SITE PLAN REVIEW

LOT NO 264 REGISTERED PLAN 654-4500

GOLD PARK HOMES

SITE PLAN

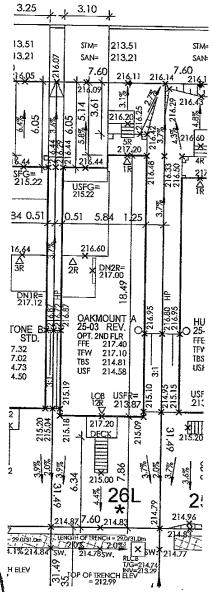
THE PROPOSED LOT GRADING AND DRAINAGE IS APPROVED AS BEING IN CONFORMITY WITH THE OVERALL APPROVED GRADING PLANS FOR THE SUBDIVISION.
